# SERVICE BULLETIN

| Classification:<br>EC08-017a | Reference:<br>NTB08-074a | Date:<br>April 27, 2009 |

## 2007 SENTRA & VERSA; DTC P0031, P2A00, P1148

**APPLIED VEHICLE:** 2007 Versa (C11) and Sentra (B16) with MR engine **ONLY**

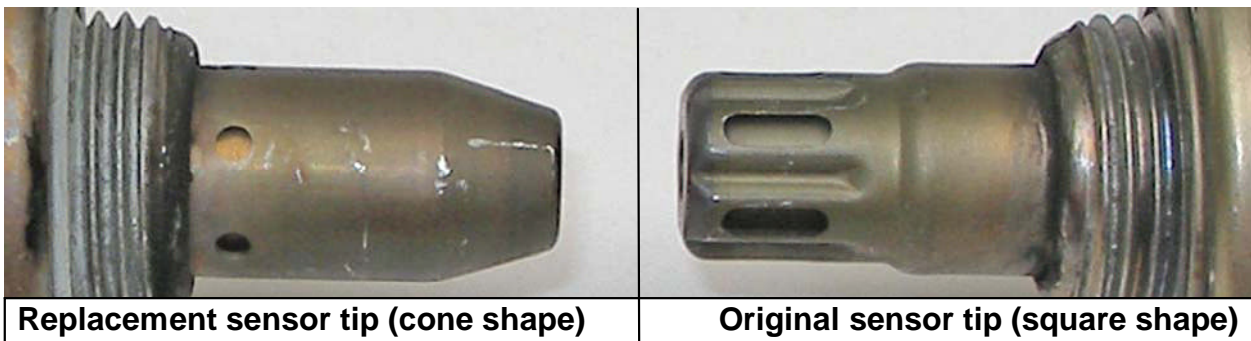
- Use the new A/F sensor listed in the Parts Information.
- The original and replacement sensors look different, see below.

| DESCRIPTION                  | PART #      | QUANTITY |
|------------------------------|-------------|----------|
| Sensor Assy – Air Fuel Ratio | 22693-1AA0B | 1        |

Figure 6

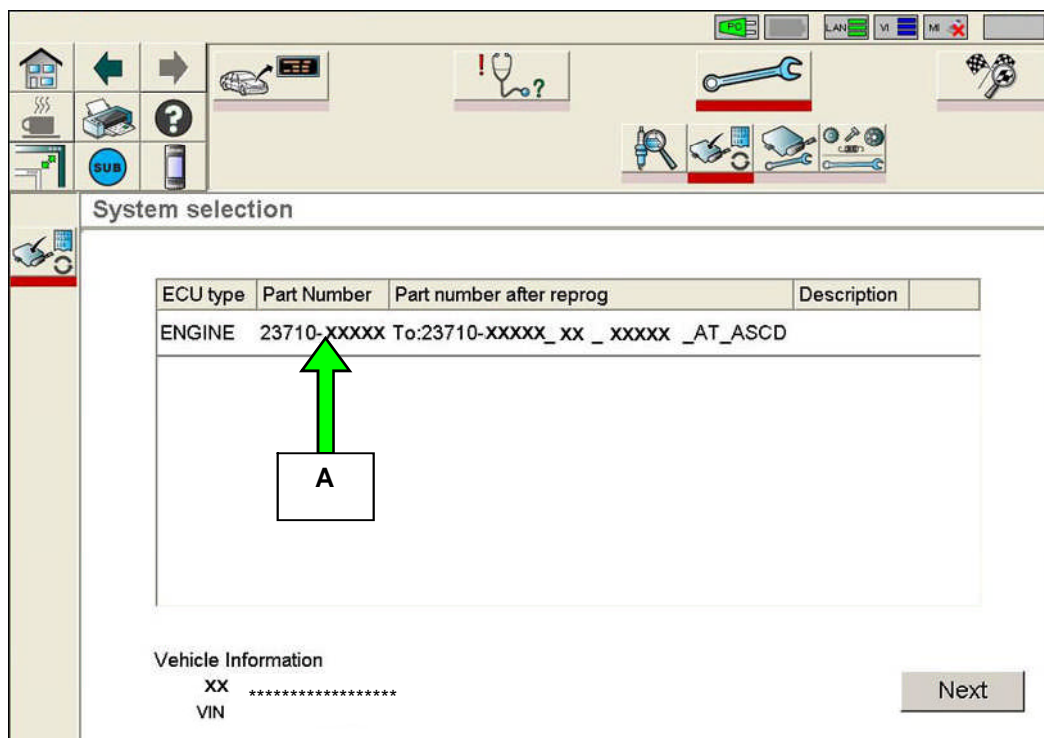
2. When you get to the ECM Reprogramming screen shown in Figure 1, confirm this bulletin applies as follows:

A. On your C-III screen, look at the **Part Number** column (see Figure 1):

- If this column is **blank** (no part number listed), this **bulletin does not apply**. Close C-III and refer to ASIST for further diagnostic information.
- If a Part Number is listed, write it on the Repair Order.
